BOARD OF COMMISSIONERS
AGENDA
Monday, August 13, 2018 - 6:30 PM

- F. Resolution #2018-83 - 409, 411, 413 East Lancaster Avenue, Emerson, **Final Land Development** (Requesting a waiver)

RECORD PLAN: (SHEET 1 OF 1 FOR RECORDING) FILE NO.: 15-369

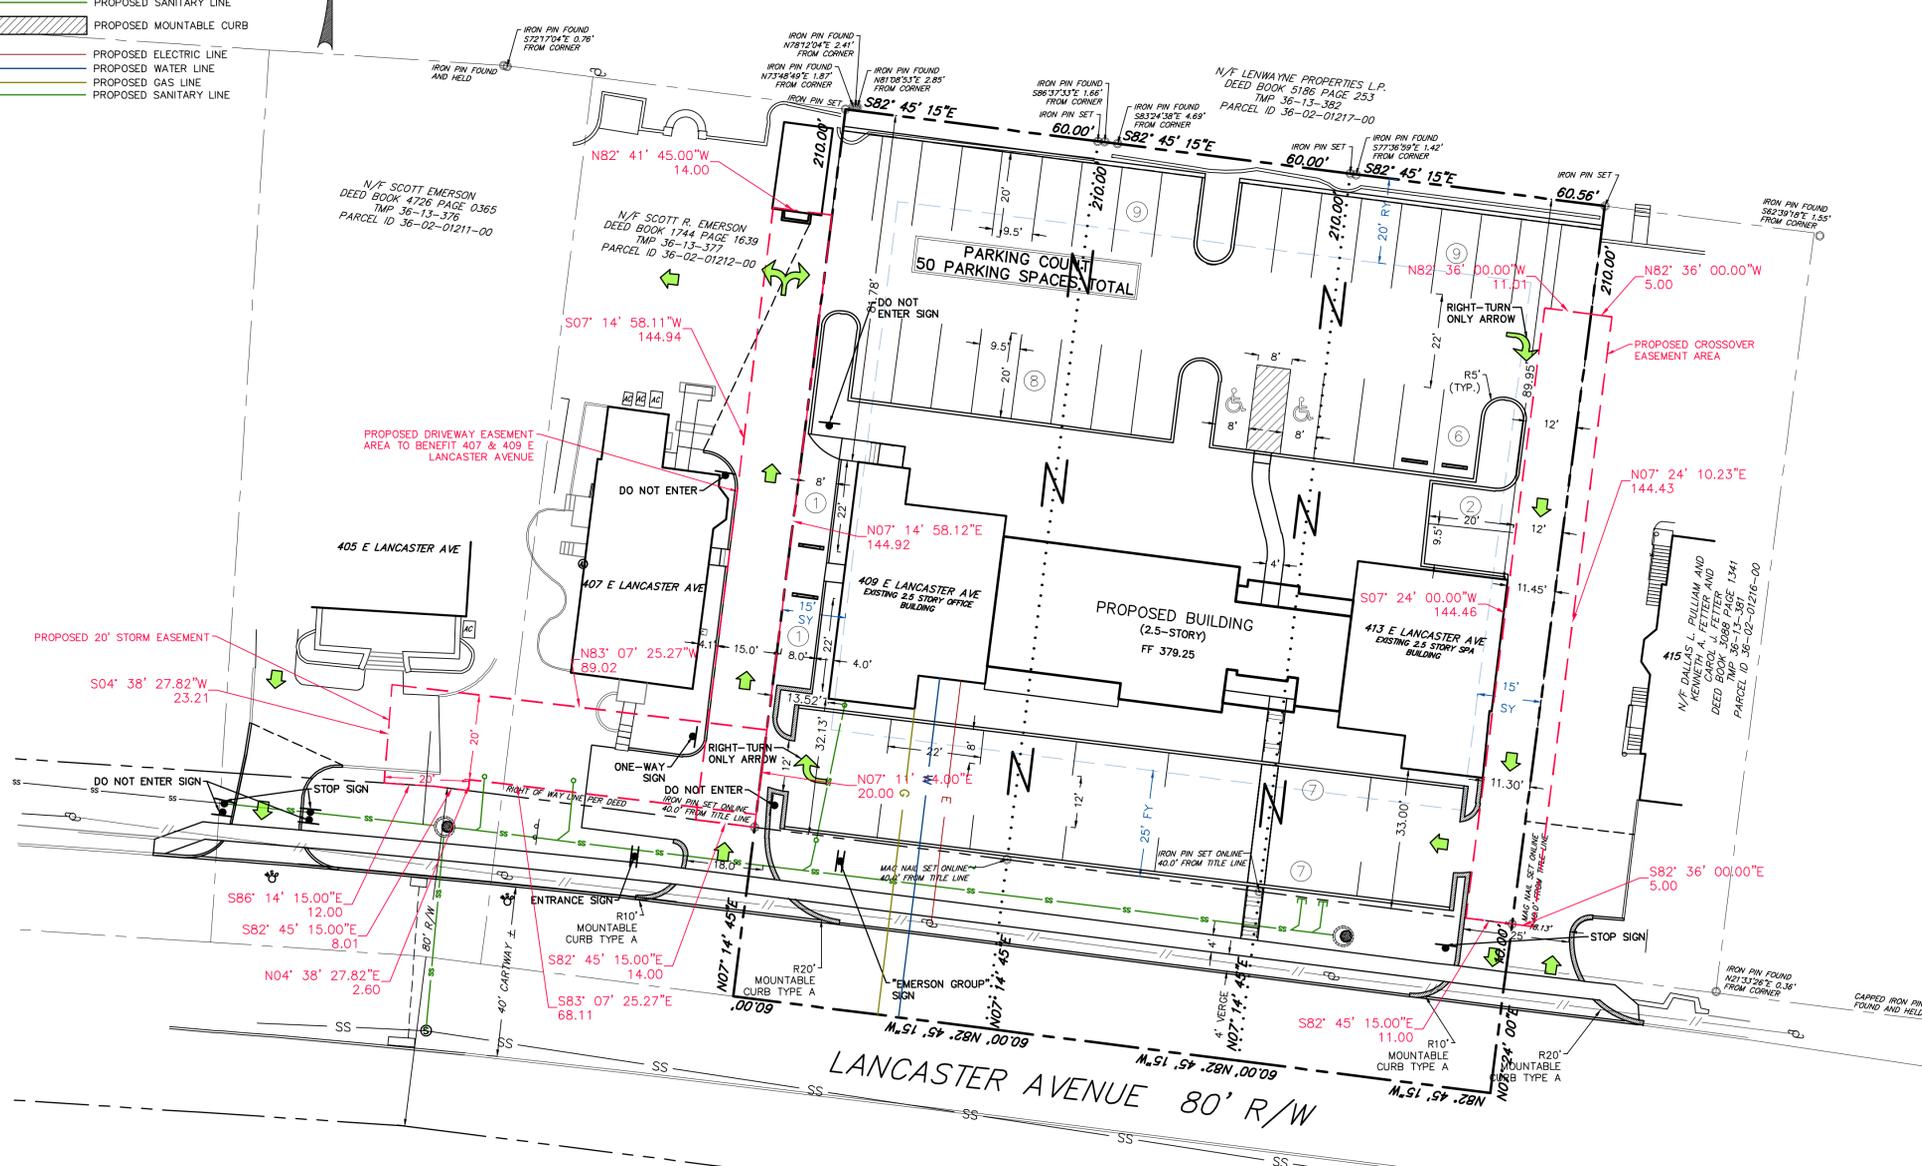
3. *Revise Sheet 2 (Record Plan) to include the proposed signage.*

Sheet 2 has been revised to include the signage.

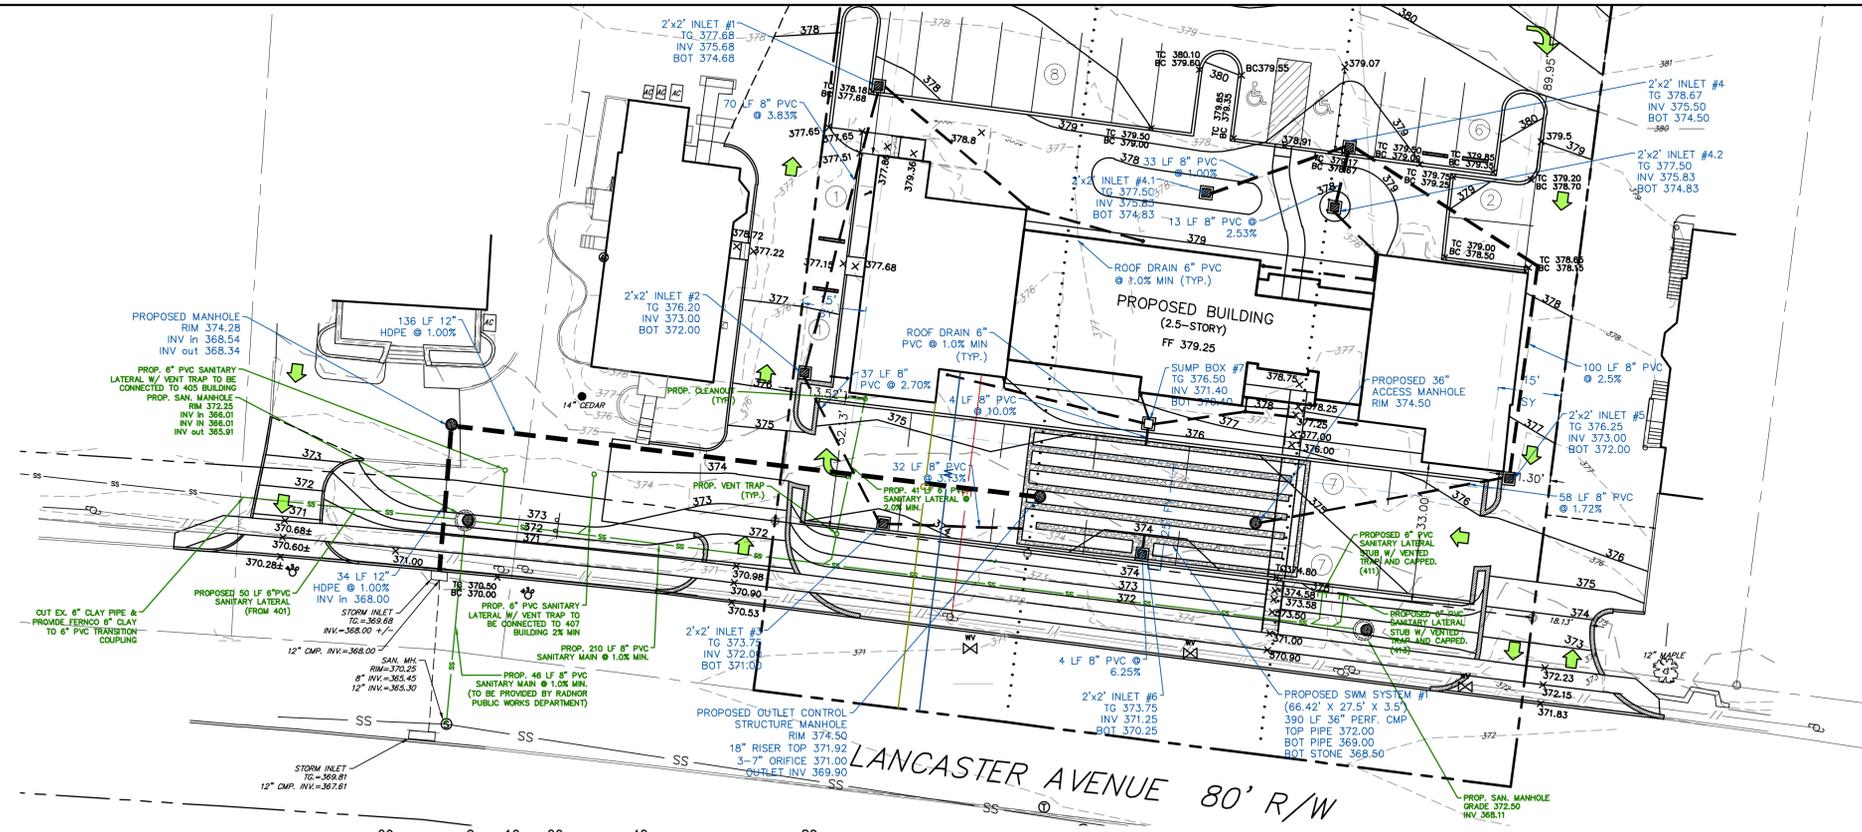
4. *The minimum coverage for sanitary sewer is 5 feet. The sanitary sewer profile on Sheet 12 shows the proposed sanitary sewer with less than 5 feet of cover.*

4. The minimum coverage for sanitary sewer is 5 feet. The sanitary sewer profile on sheet 12 shows proposed sanitary sewer with less than 5 feet of cover.

TREES TO BE REMOVED
Emerson Group
RADNOR TOWNSHIP, DELAWARE COUNTY, PENNSYLVANIA

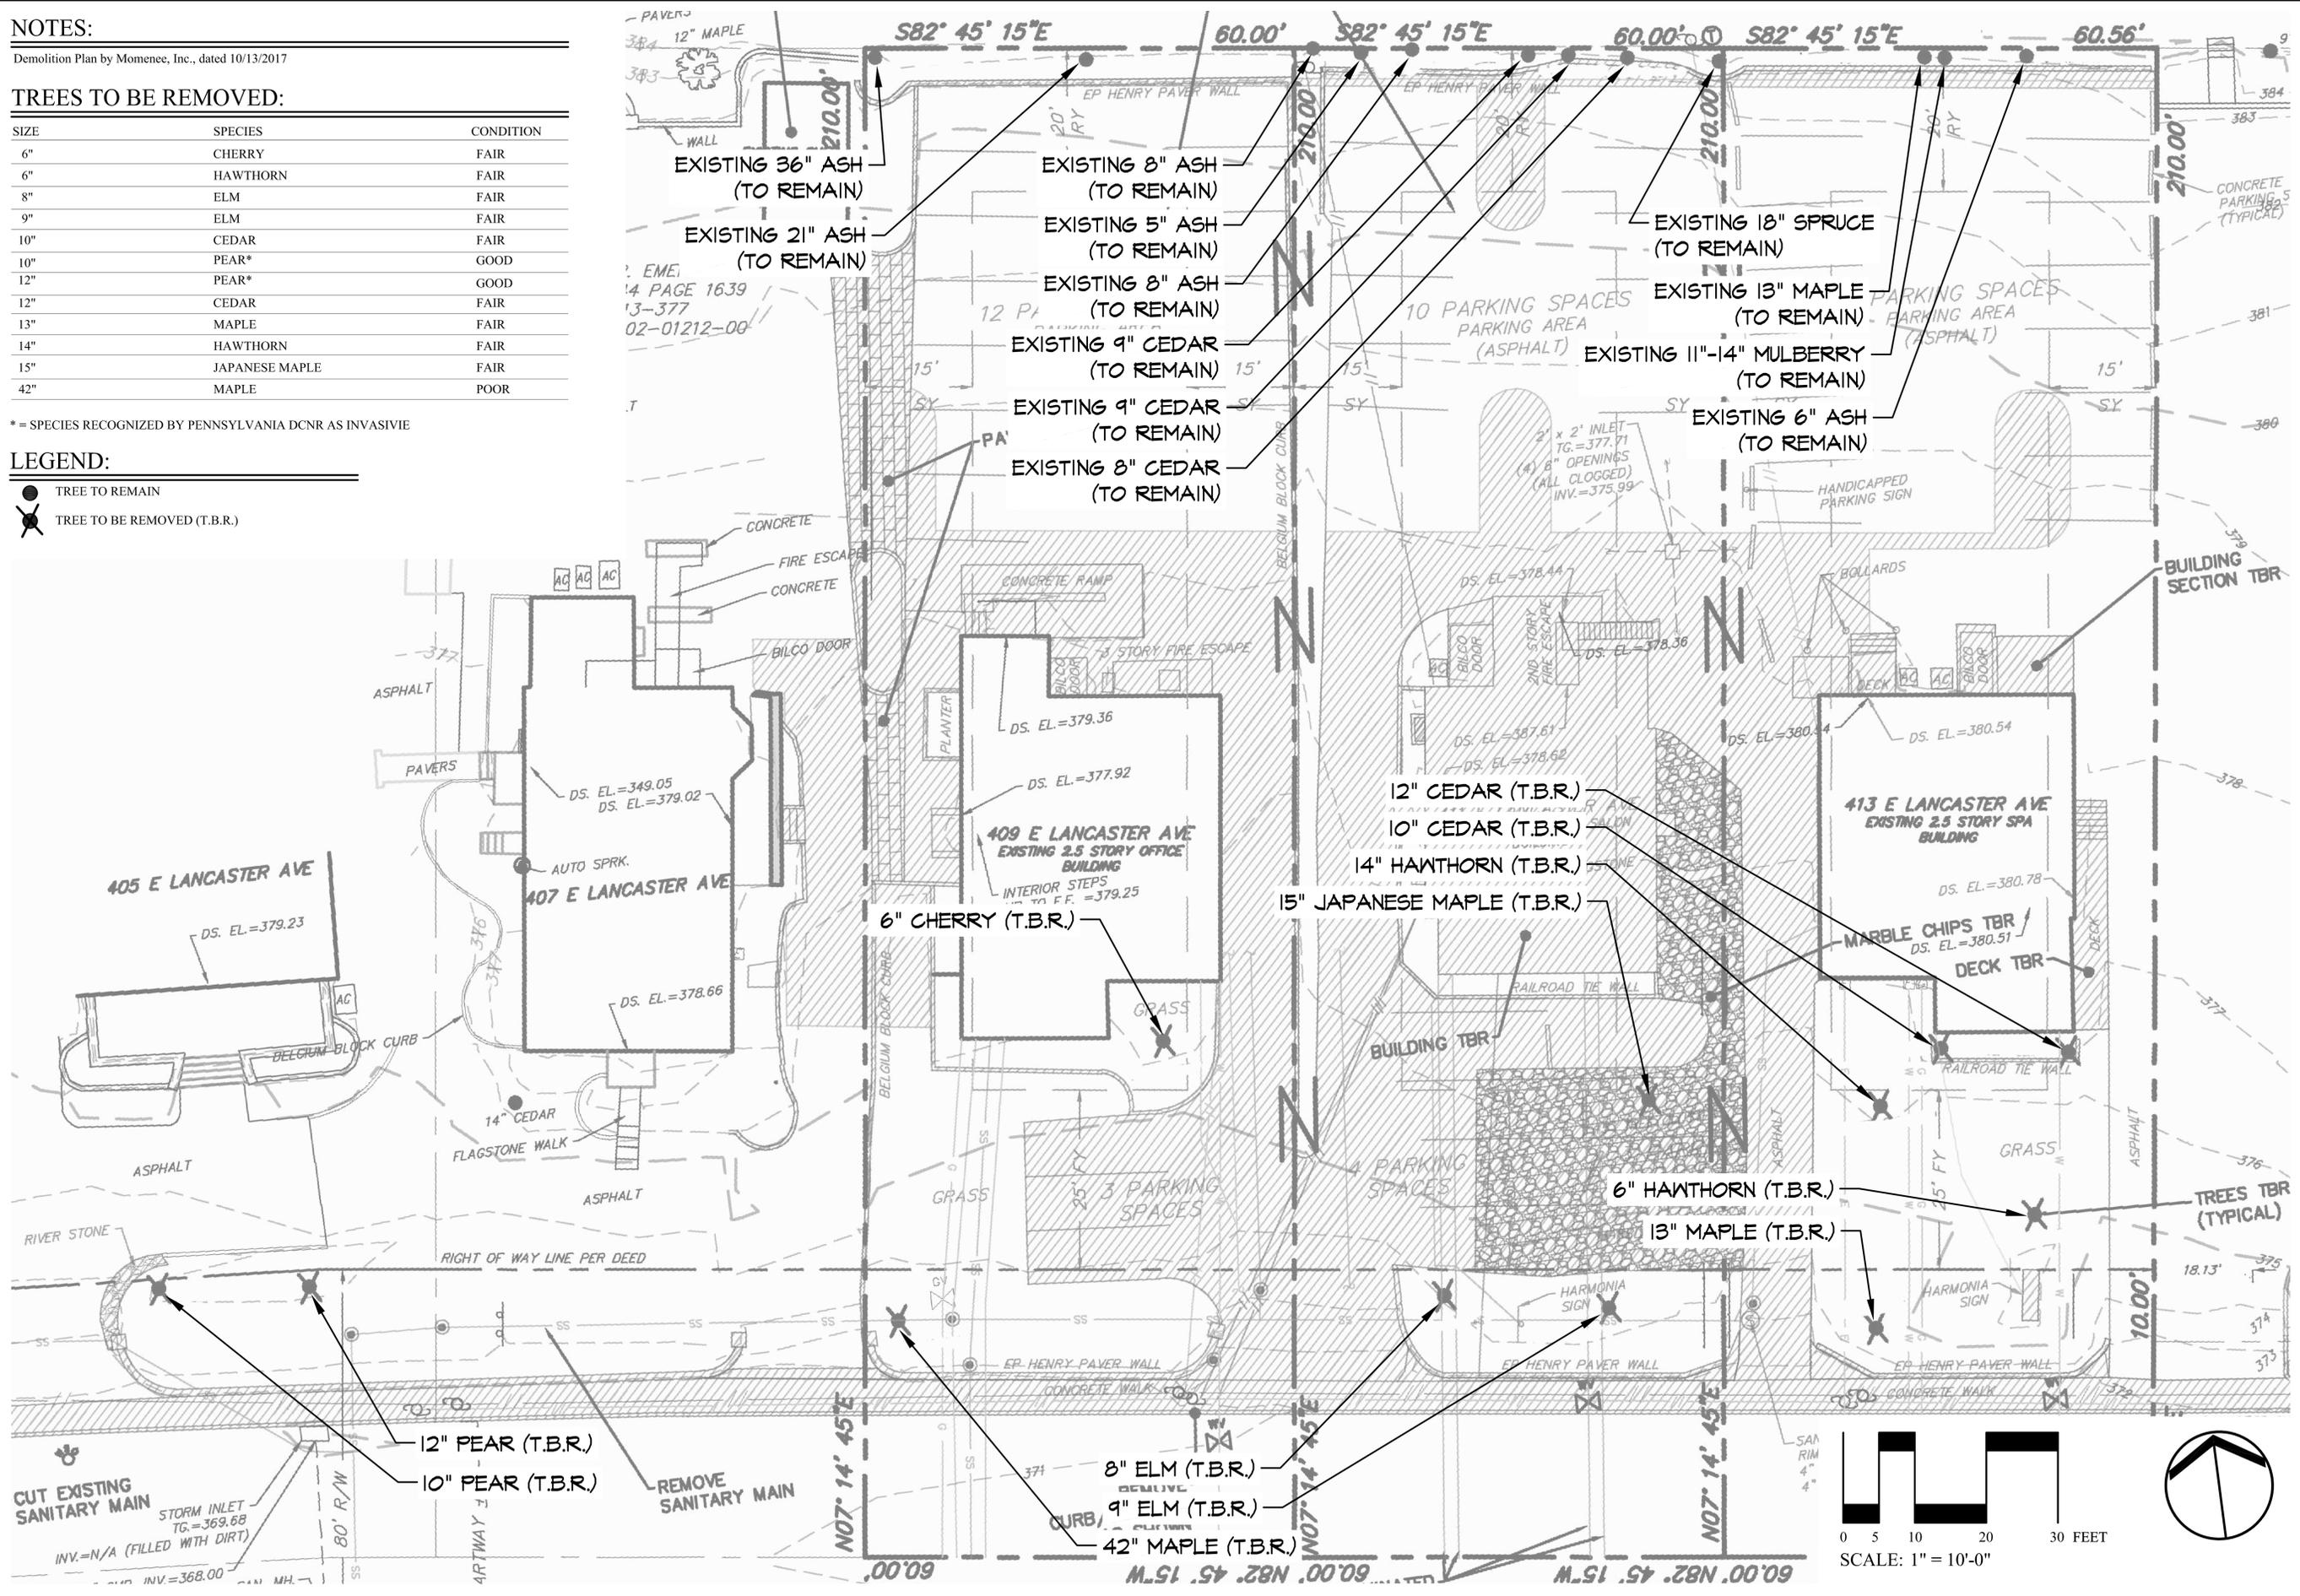
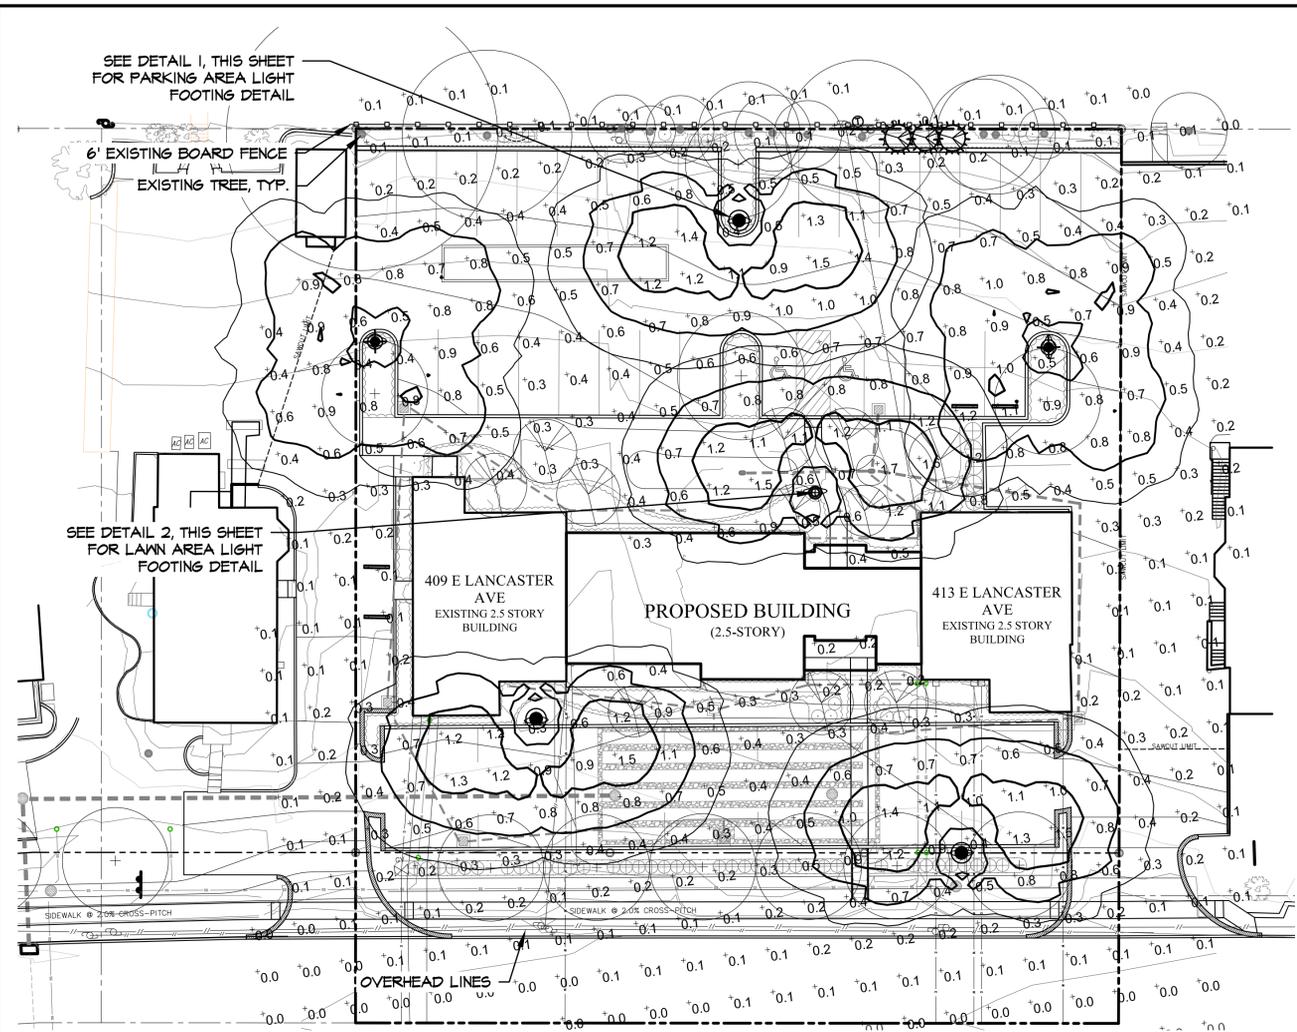
4. §255-38.H(1) – Some of the trees listed on sheet LP-1 are not in accordance with what is listed in this section. The Board of Commissioners can approved other species. The applicant appeared before the Shade Tree Commission on July 26, 2017 and obtained approval.

4. *§255-38.H(1) – Some of the trees listed on sheet LP-1 are not in accordance with what is listed in this section. The Board of Commissioners can approved other species. The applicant appeared before the Shade Tree Commission on July 26, 2017 and obtained approval.*
